# SAFETY RECALL BULLETIN

## NHTSA RECALL 15V289

AUTOCAR, LLC SAFETY RECALL ACX-1502

Replacement of the parking brake synchronization (synchro valve) on certain Xpeditor chassis.

**Figure 1**

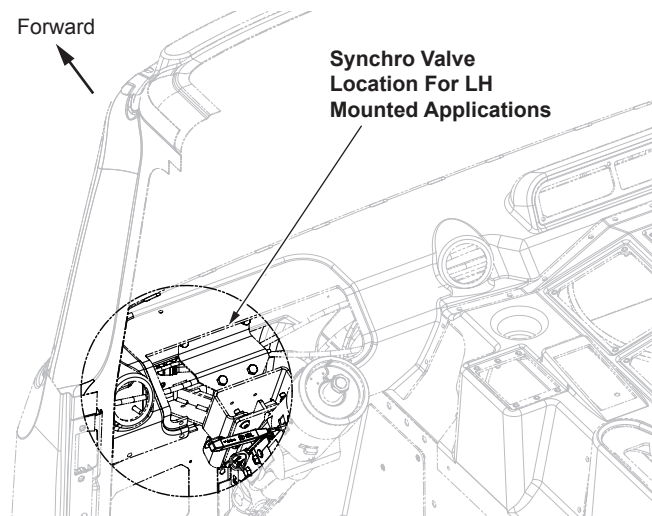
1. Locate the synchro valve mounted opposite the HVAC case. Refer to Figure 1 or Figure 2 for LH or RH mounted applications.

**Figure 3**

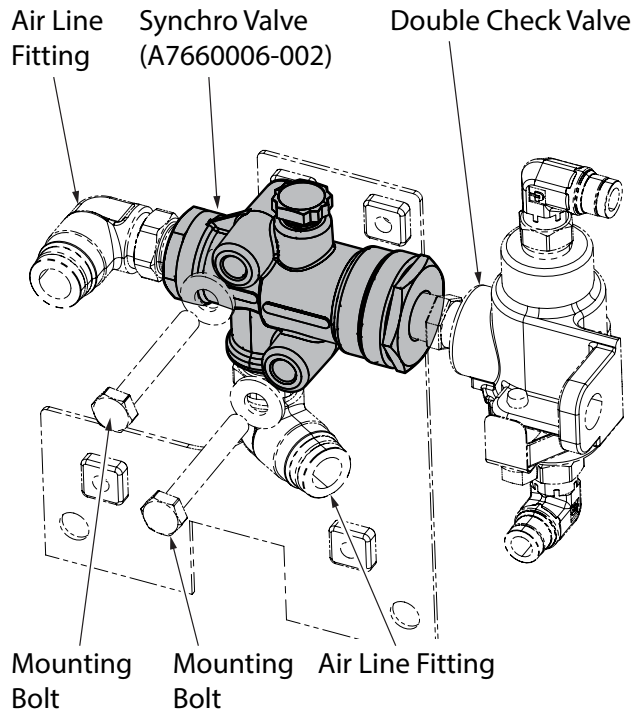
2. Disconnect all air lines to the synchro valve and the double check valve assembly.
3. Remove the valve assembly (synchro and double check valve) by removing the 2 mounting bolts and set the mounting bolts aside for reinstallation) (*see Figure 3*).
4. Separate the synchro valve from the double check valve and place the double check valve aside for reassembly.
5. Remove the air line fittings from the synchro valve and set aside for reinstallation (*see Figure 3*).
6. Discard the synchro valve.
7. Install the air line fittings into the new synchro valve (A7660006-002).
8. Assemble the synchro valve to the double check valve that was set aside in step 4.
9. Install the synchro valve and double check valve assembly by connecting the air lines that were disconnected in step 1.

**Note:** *The white exhaust line is no longer used, as the new synchro valve (A7660006-002) has an exhaust port that does not require a line. The white exhaust line can be removed and discarded or cut off as needed.*
